**REMARKS**

U.S. Application No. 09/625,201

# ANNOTATED MARKED-UP DRAWING

FIG. 1(a)

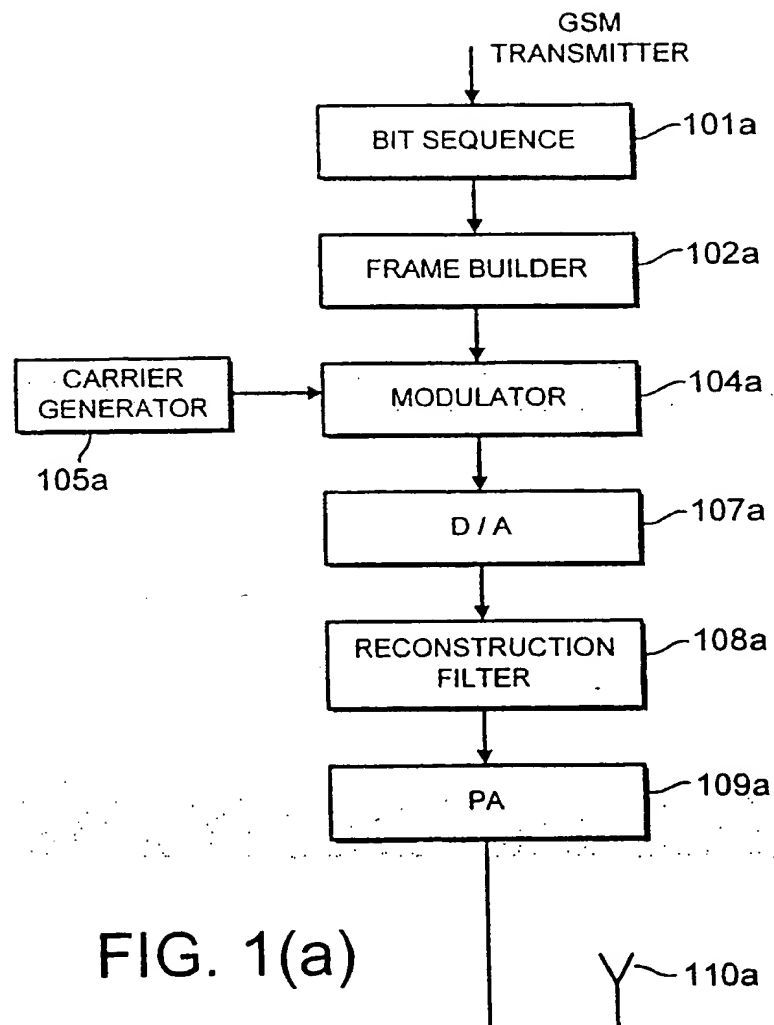
Figs. 1(a) - 1(c) and 9 have been objected to, as the Examiner requires that a legend such as "Prior Art" be included. Applicant has amended these figures to further clarify the invention and respectfully request that these objections be withdrawn.

PRIOR ART

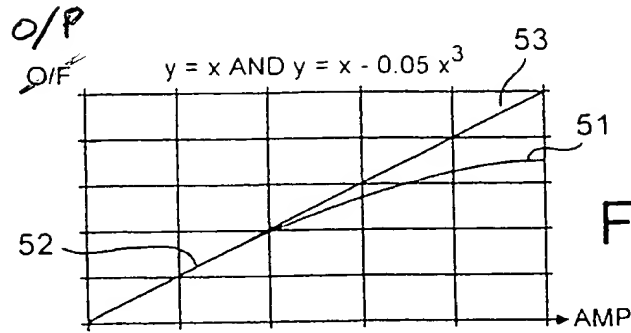
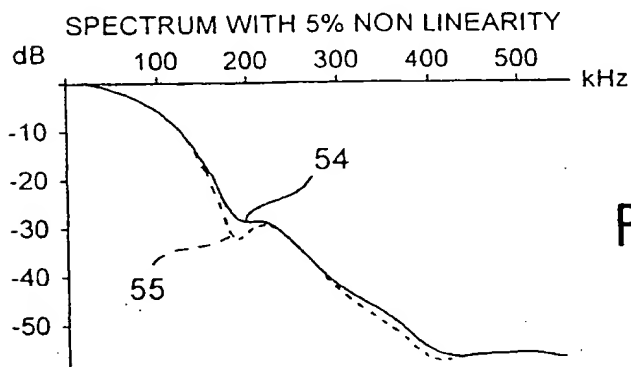
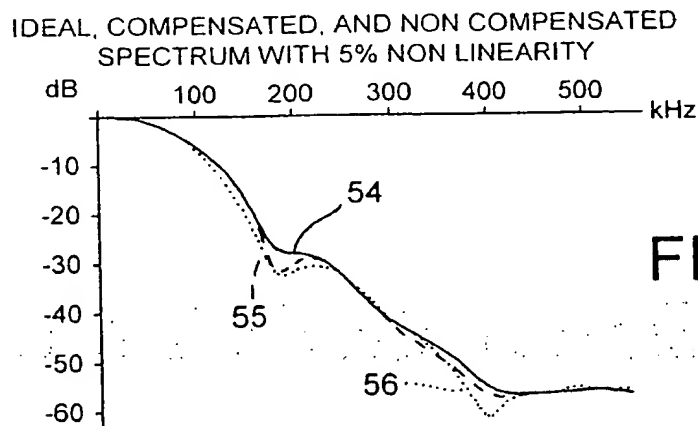
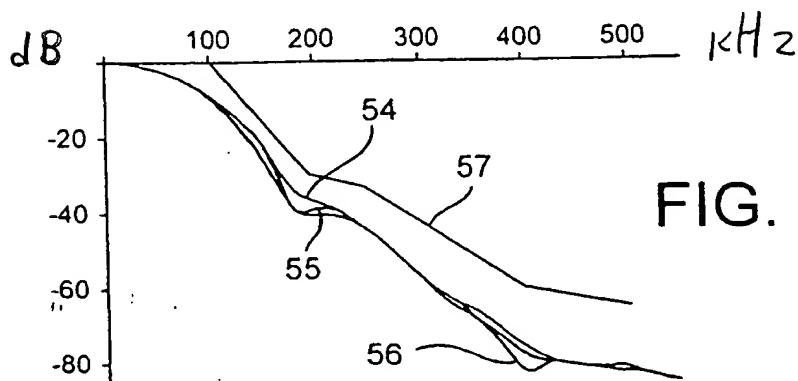
Figs. 5(a) - 5(d), 6(a) - 6(f), 9 and 10 have been objected to since the axes do not have labels. Applicants submit that Figs. 5(b) and 5(c) have appropriate labels "dB" and "kHz" on the y-axis and x-axis, respectively. Applicants have amended the figures without labels to further clarify the invention and respectfully request that these objections be withdrawn.
